License to Operate On-Site Sewage Treatment and Disposal Facility

Issued This Date: 06/19/2020 Permit Number: 110602

Location Description: 8175 BRACKEN CREEK DR
SAN ANTONIO, TX 78266

COMAL COUNTY OFFICE OF ENVIRONMENTAL HEALTH ***
APPLICATION FOR PERMIT FOR AUTHORIZATION TO CONSTRUCT AN
ON-SITE SEWAGE FACILITY AND LICENSE TO OPERATE

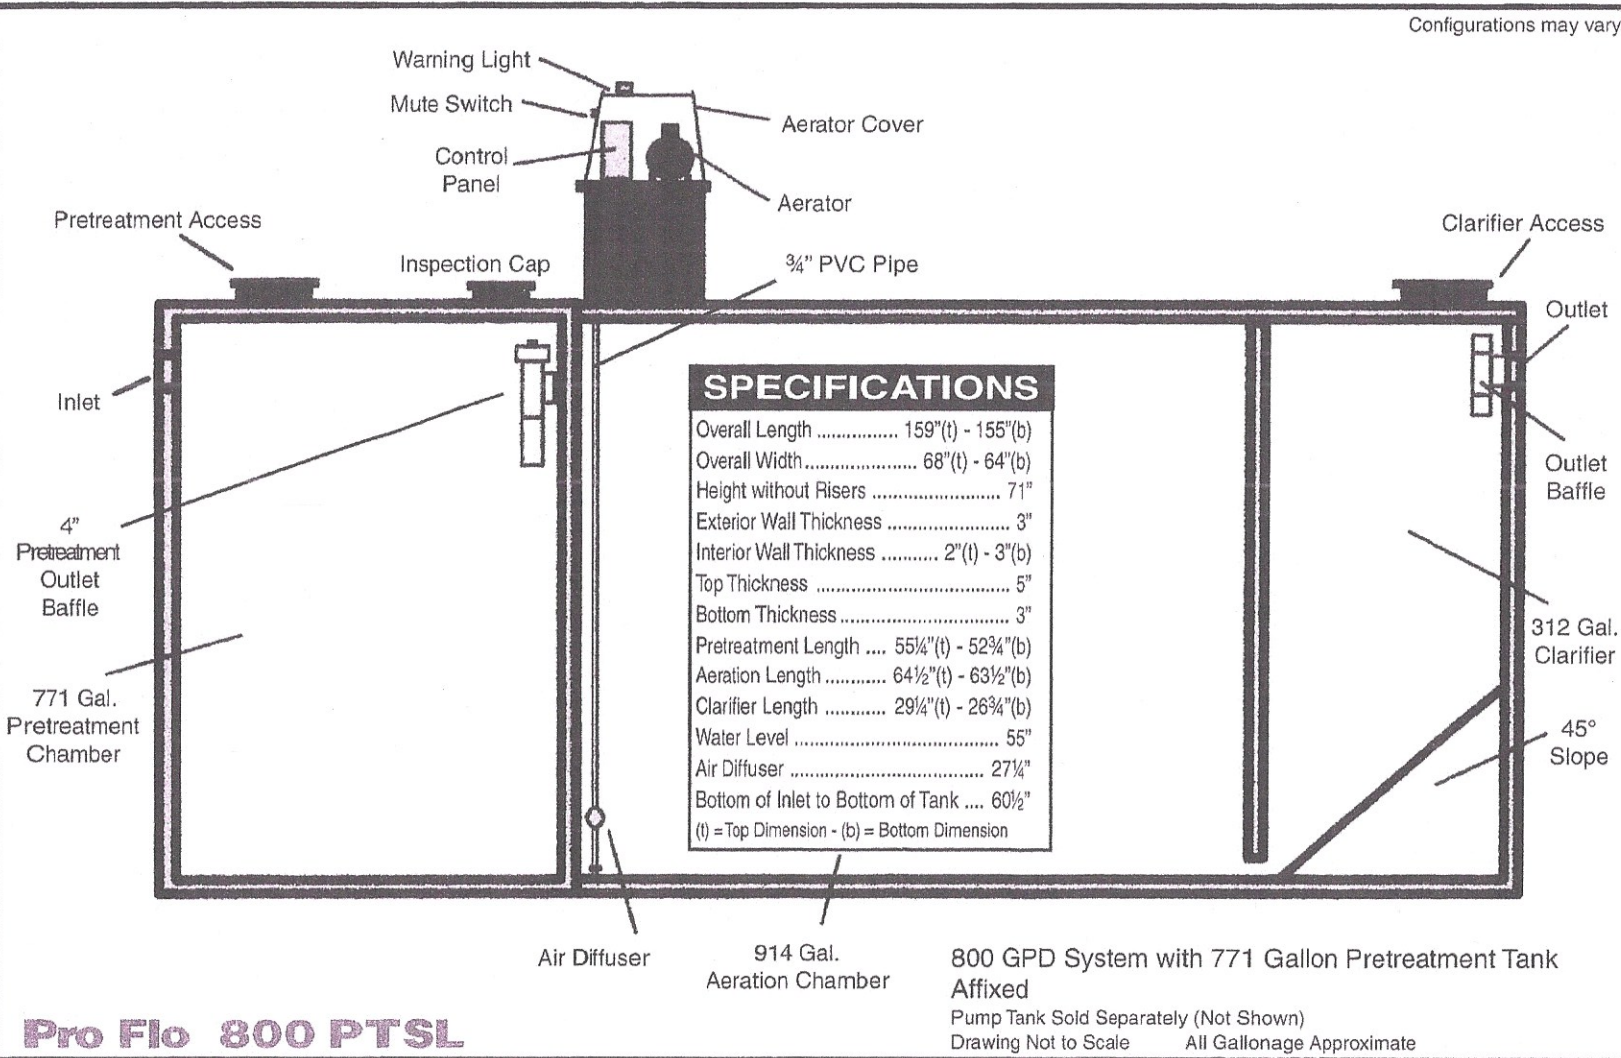
1. ✓ The recorded plat indicates that there is also a 30' variable width drainage easement on the referenced property that is not shown on the design.
2. ✓ Show the dimensions of the amended lot (9R) on your site plan.
3. ✓ Submit a copy of the recorded deed and/or amendment to plat for this property (lot 9R).
4. ✓ Indicate that the tank will be pumped before it is removed.

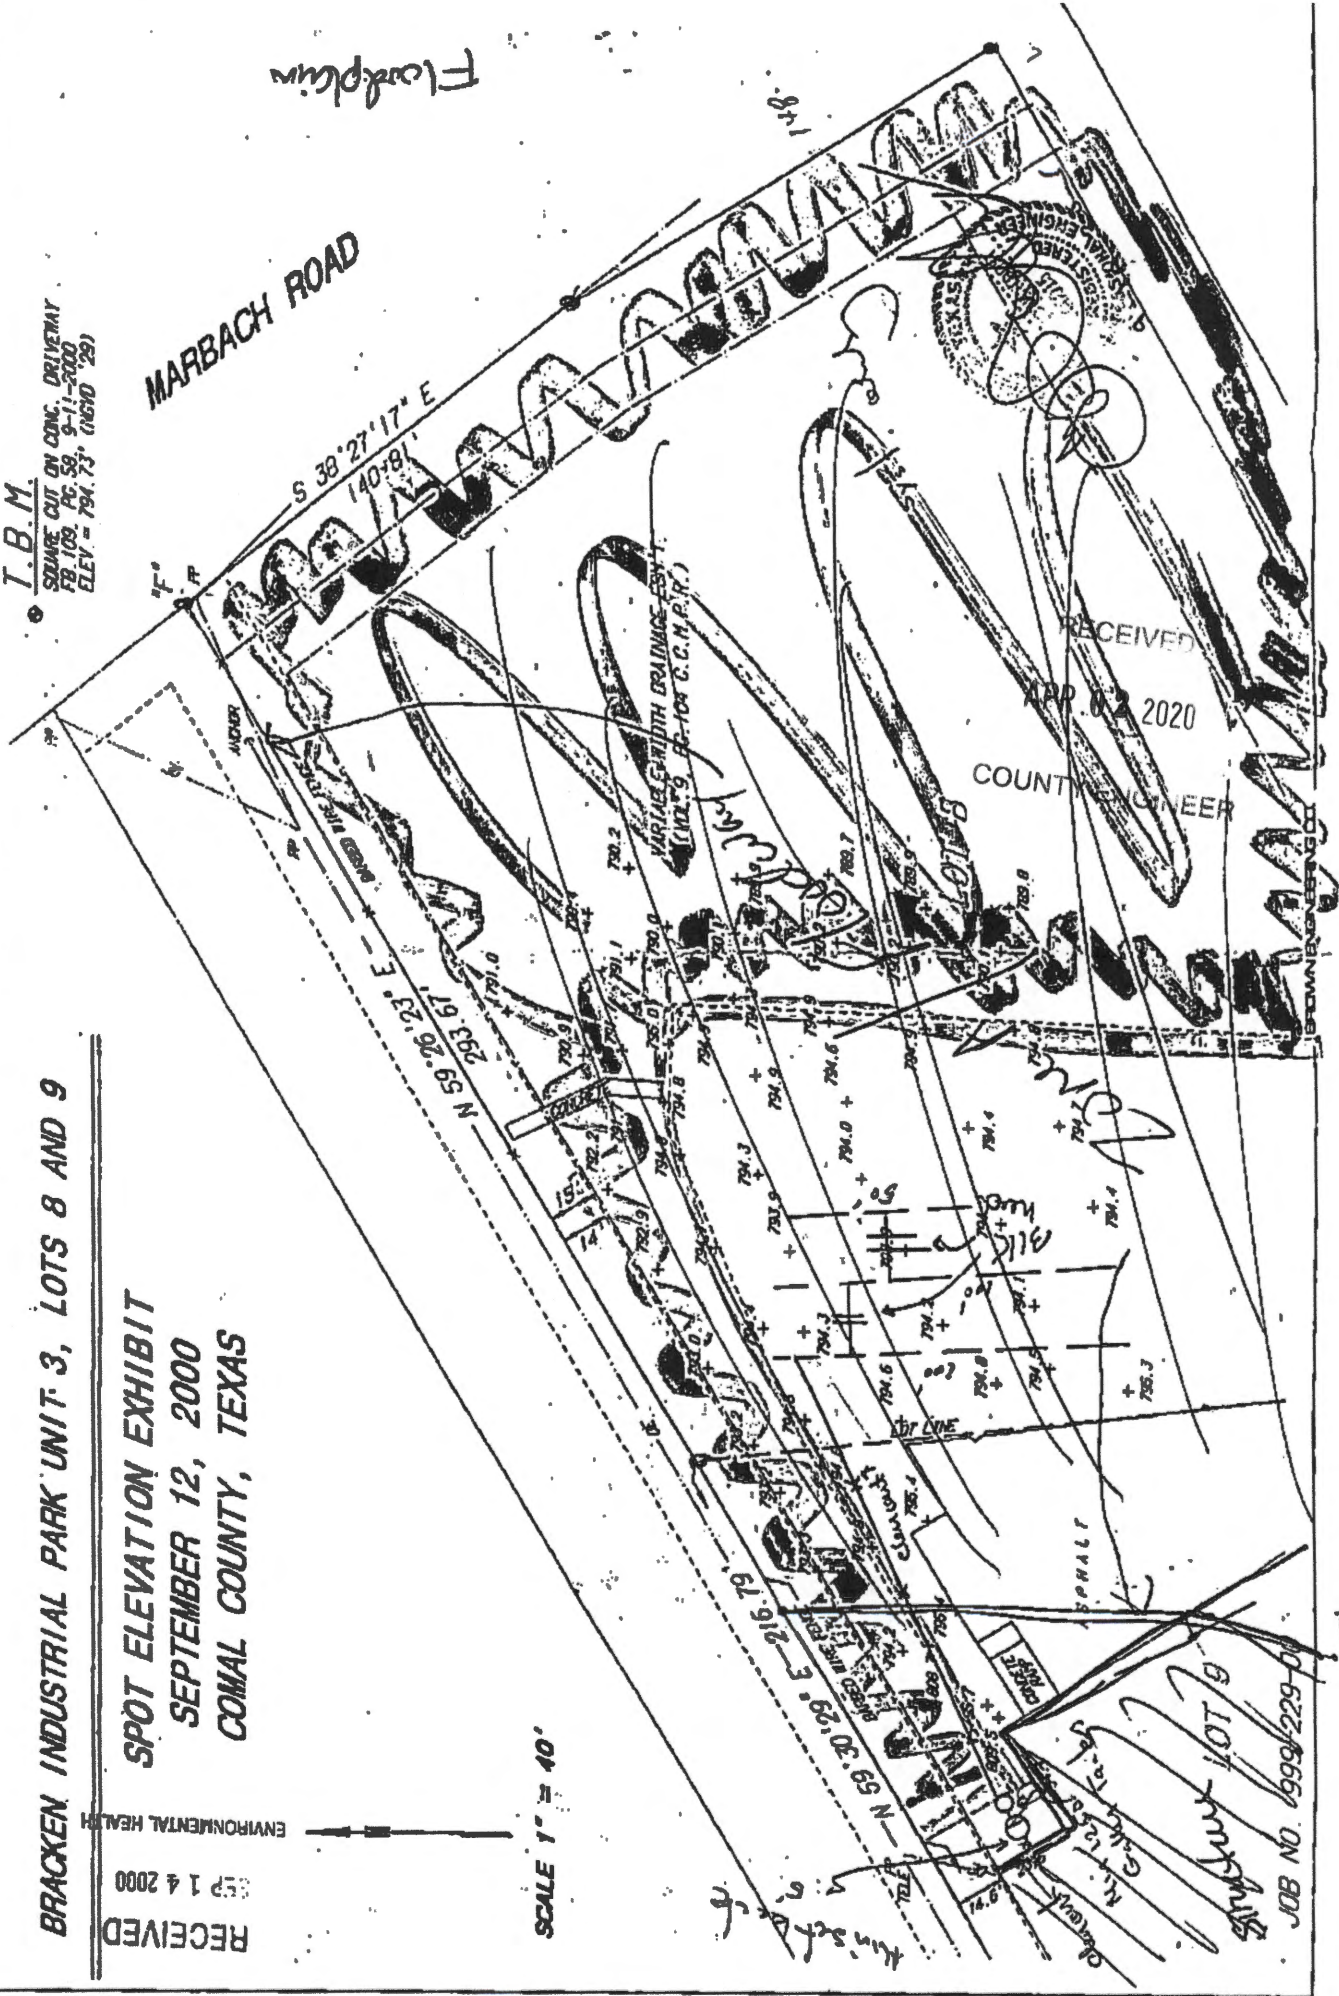
1.  Show the driveway and parking location on the site plan.
2. The recorded plat indicates that there is a 14 foot electrical, telephone, gas and cavtv easement on the referenced property that is not shown on the design.

3. The site plan does not appear to match the dimensions shown on the recorded plat.
4. It appears that the recorded deed that was submitted to our office is for a different property. Submit a copy of the correct deed and/or copy of recorded amendment to plat.
